Planning Commission  
Date: 5/10/10  
**PUBLIC HEARING**  
Item: 4 a

ITEM: Conditional Use Permit Amendment: Consideration of an application from ISD 834 for the Lake Elmo Elementary School to modify the rear parking lot on the North side of the building, to add a parking lot, to widen a private roadway from Laverne Avenue North, and to add two portable classrooms and a hallway at 11030 Stillwater Boulevard North – PID's: 13-029-21-23-0001, 13-029-21-23-0002, 13-029-21-23-0003, 13-029-21-22-0004, and 13-029-21-22-0001.

<b>To:</b>	<u>Kelli Matzek, City Planner</u>	<b>Reference:</b>	<u>2010 School Addition and Parking</u>
<b>Copies To:</b>	<u>Kyle Klatt, Planning Director</u>		<u>Lot Modifications</u>
	<u>Jack Griffin, City Engineer</u>		<u>Lake Elmo Elementary</u>
<b>From:</b>	<u>Ryan Stempski, P.E.</u>	<b>Proj. No.:</b>	<u>14575.001 Phase 10</u>
<b>Date:</b>	<u>May 3, 2010</u>	<b>Routing:</b>	<u></u>

Potential Parent Pick-up/Drop-off Traffic Flow

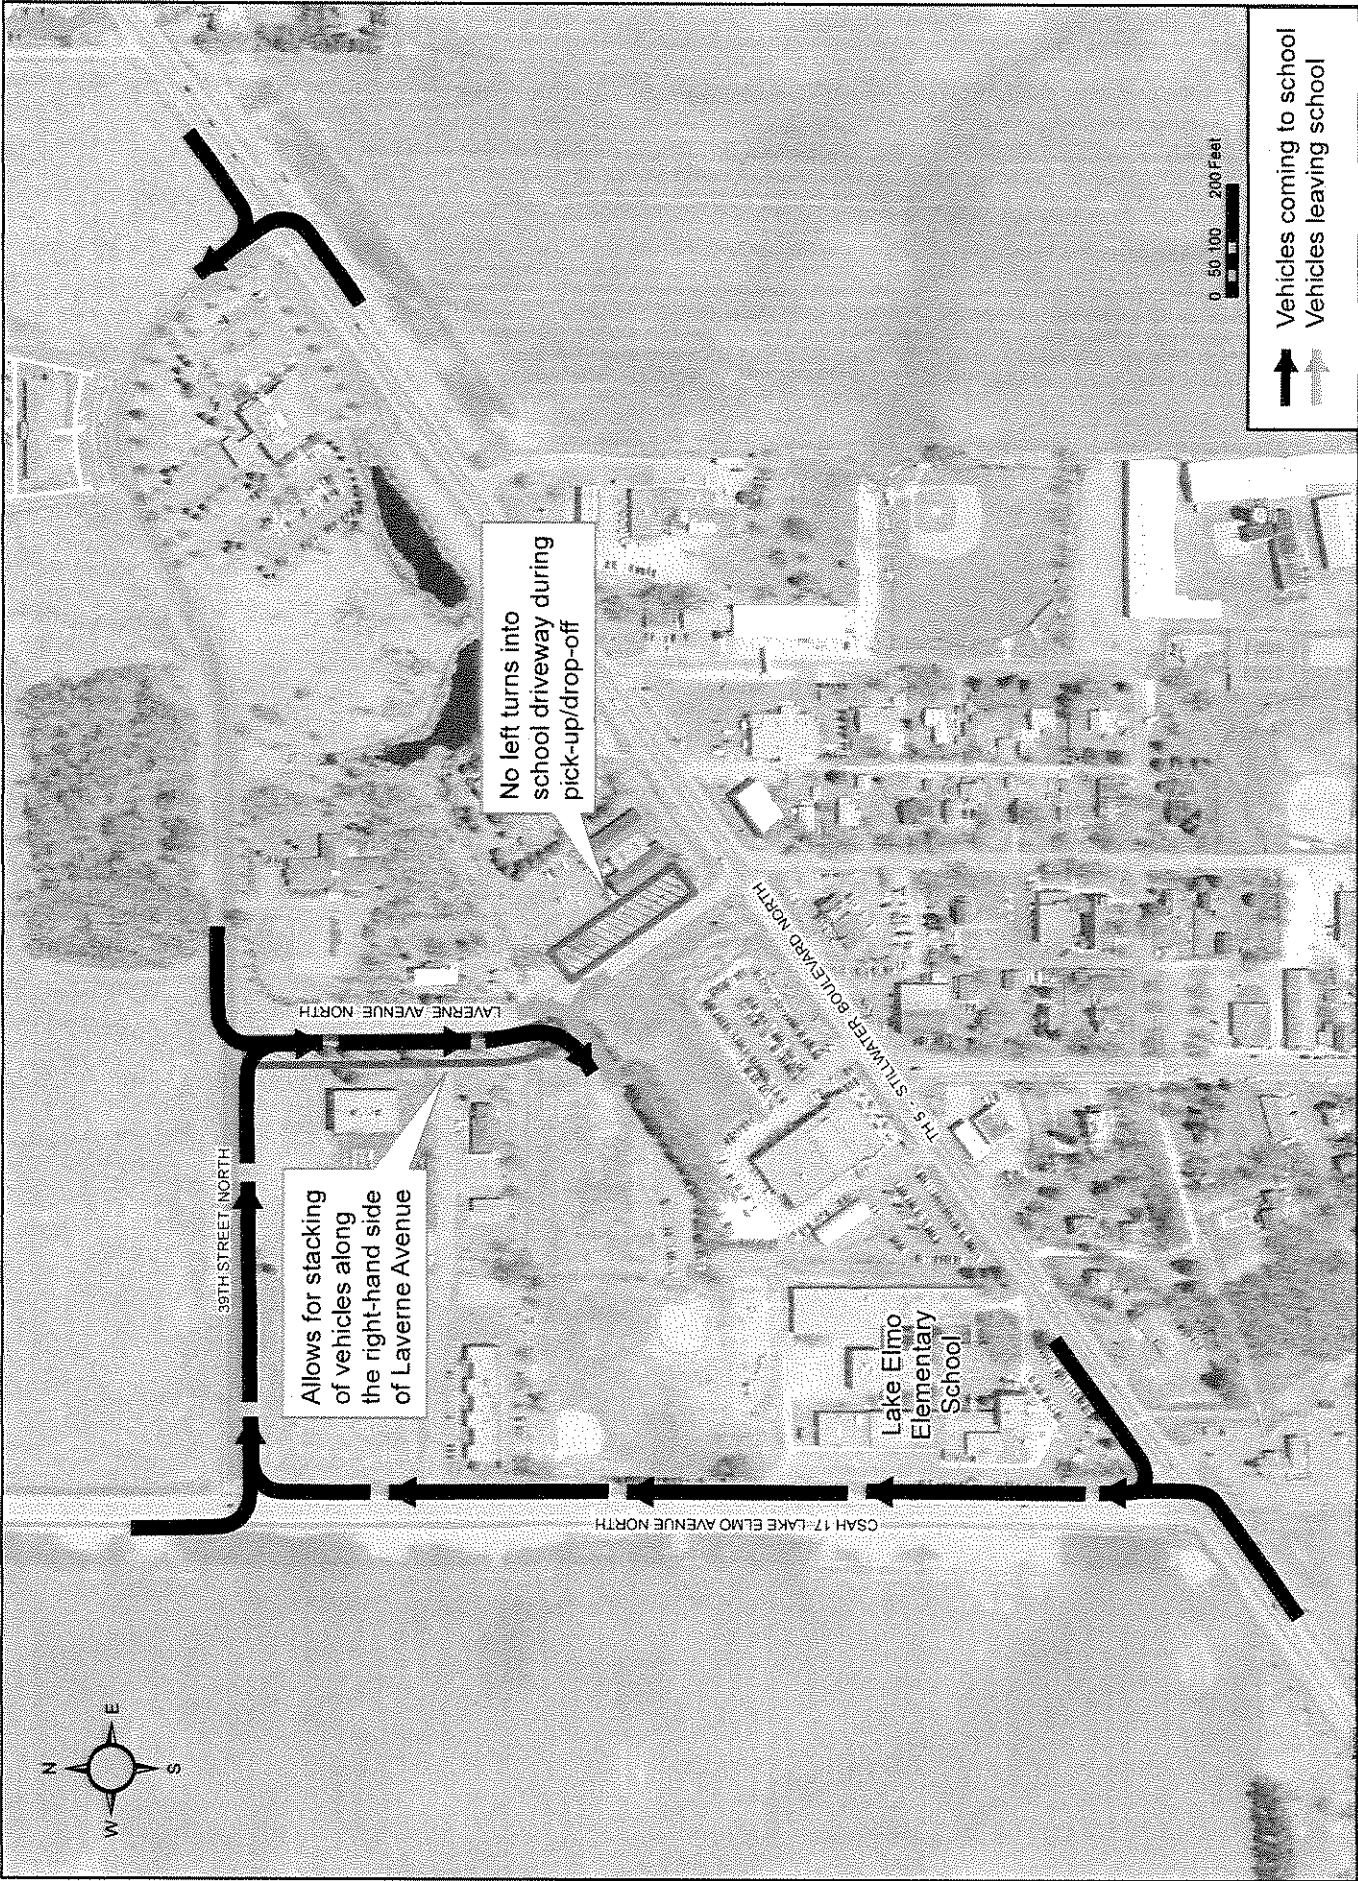
Looking one step further, we would like to suggest a potential plan for the actual pick-up/drop-off process. Attached is a graphic that shows all vehicles coming to the school for pick-up/drop-off using 39<sup>th</sup> Street North to get to Laverne Avenue North and then into the school access driveway. This would allow waiting vehicles to stack along the school driveway and then back

**TRAFFIC SIGN PLAN**

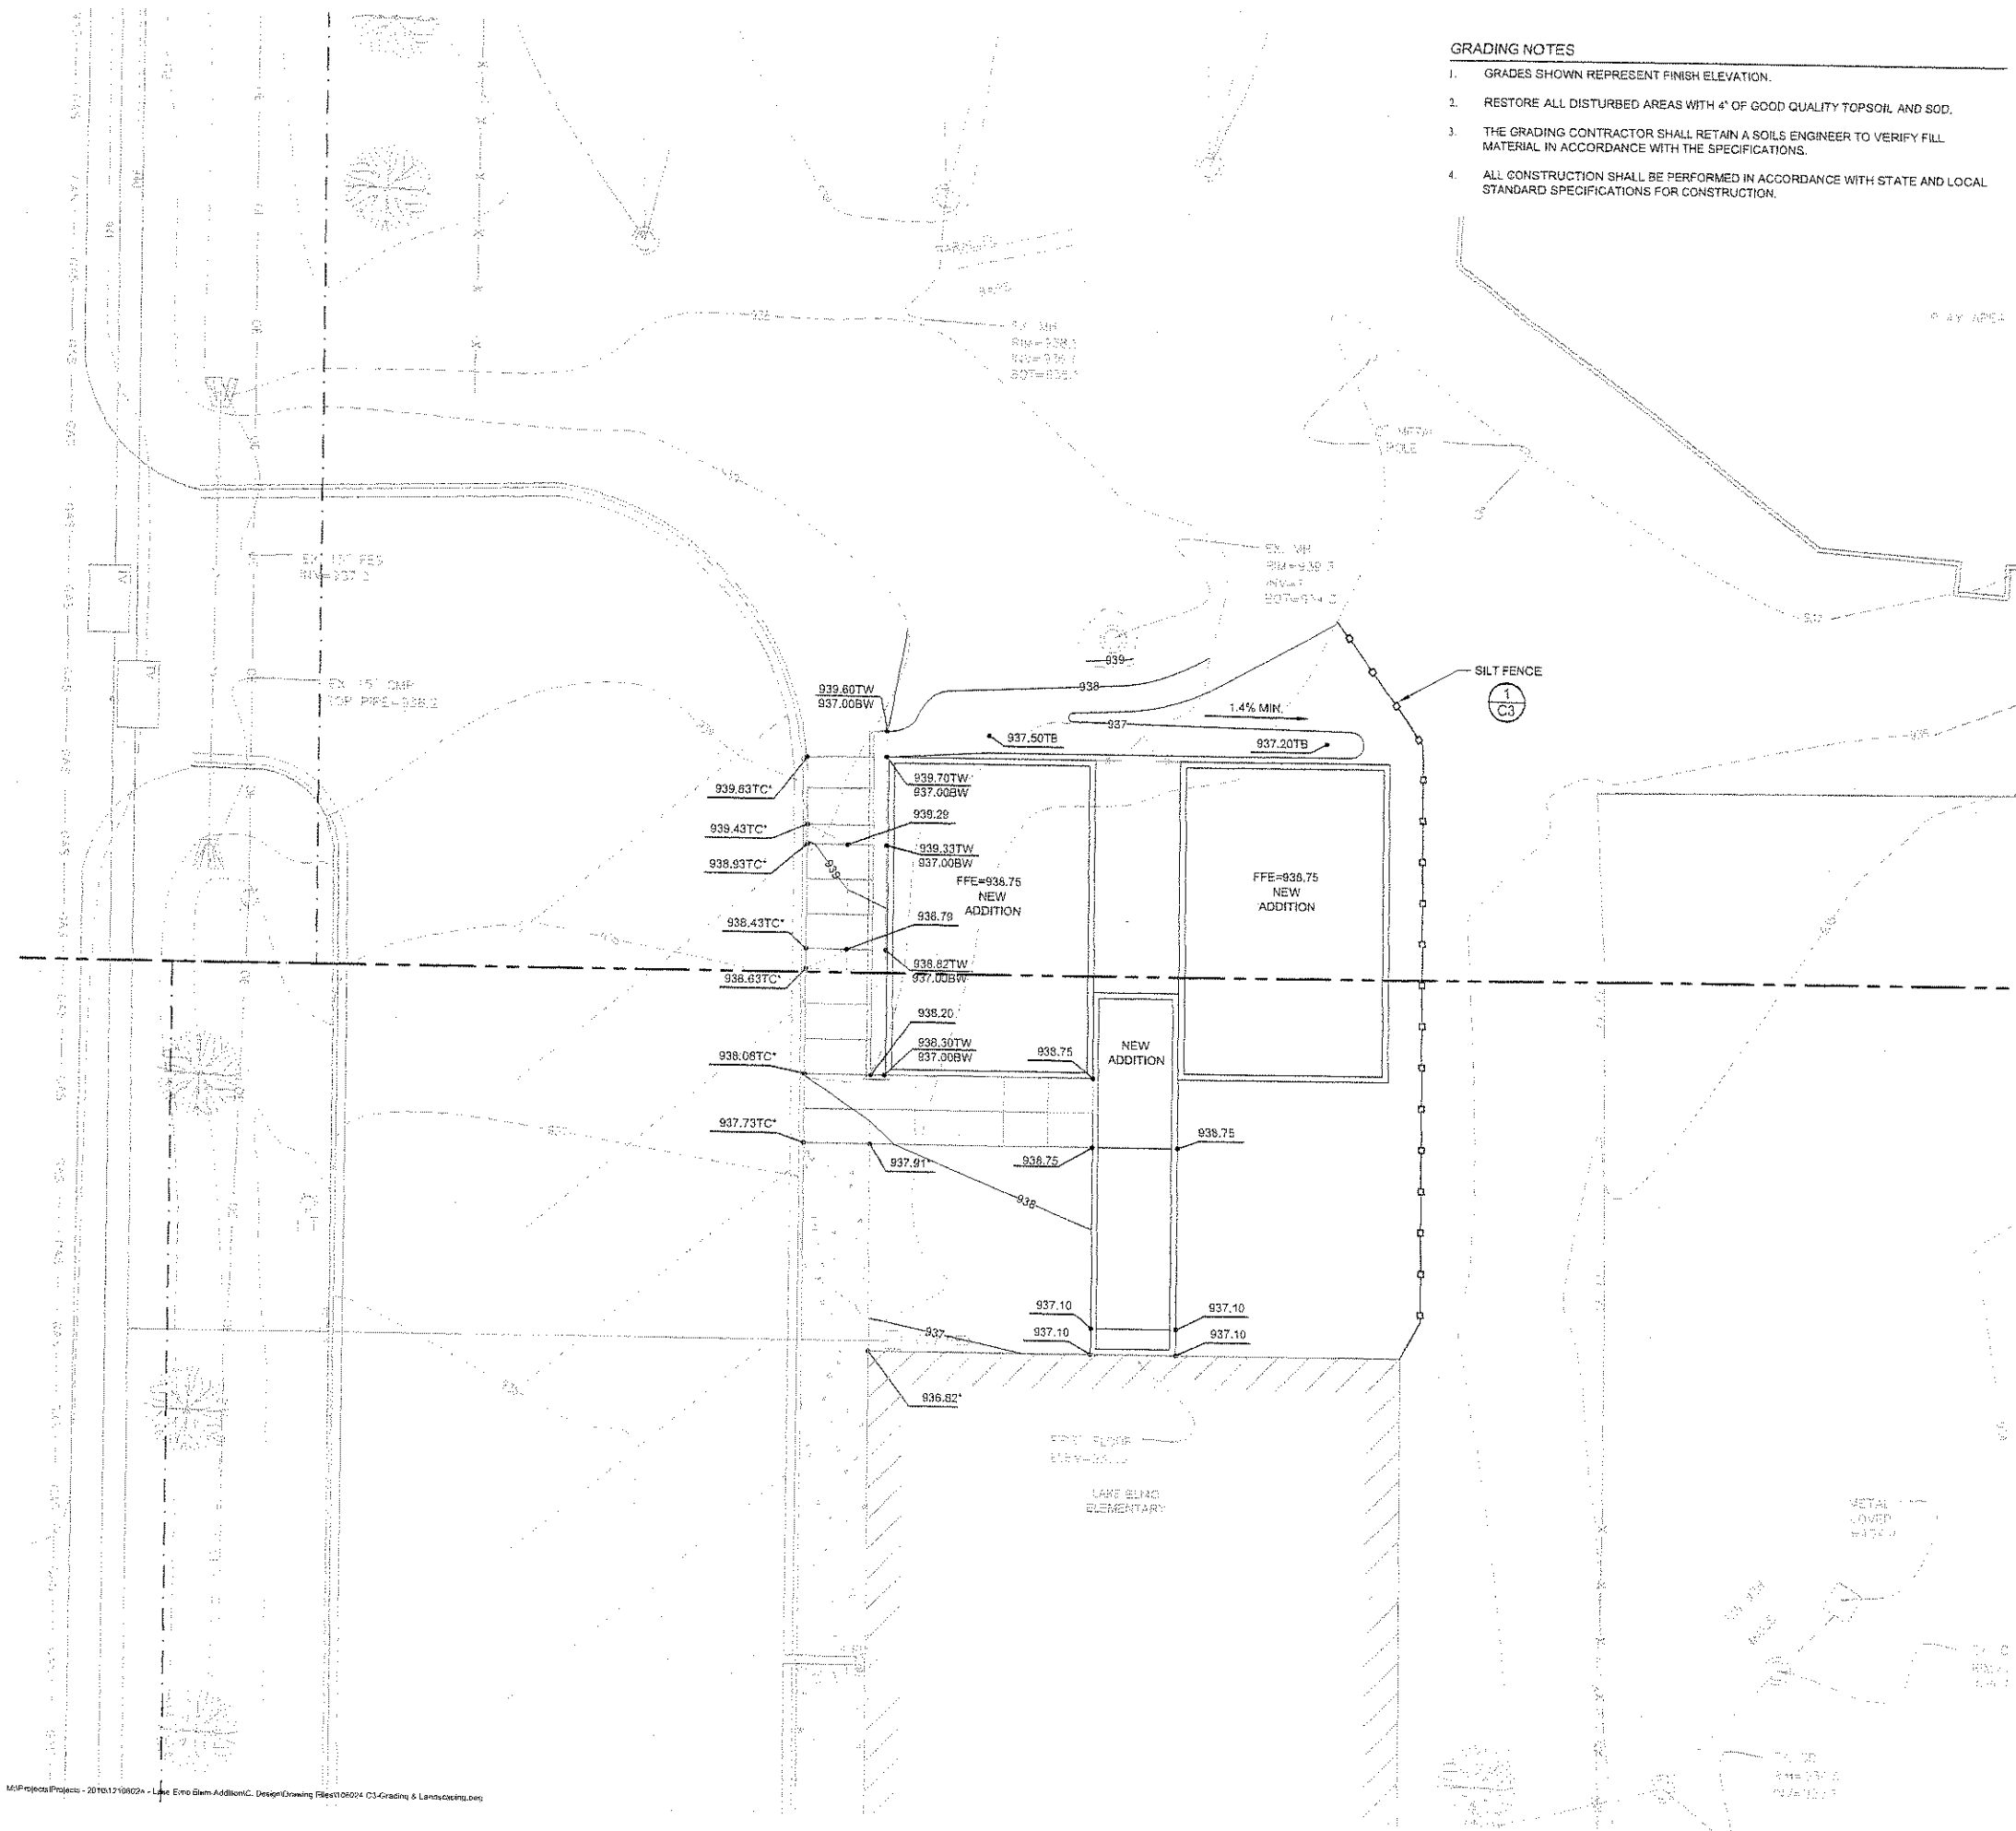
A traffic sign plan was submitted with the application. This identifies signage in conjunction with the proposed parking lot project. Staff found the signage identified was adequate for directing traffic on-site at the proposed parent drop off location to the North of the school.

- Working with Mn/DOT, Washington County, and the City of Lake Elmo, additional "Student Drop Off" Signs should be added along T.H. 5, Lake Elmo Avenue, and Laverne Avenue to promote the use of the designated drop off area for the school.
- Construction schedule must be provided.
- Haul routes must be designated and temporary storage and construction parking identified.
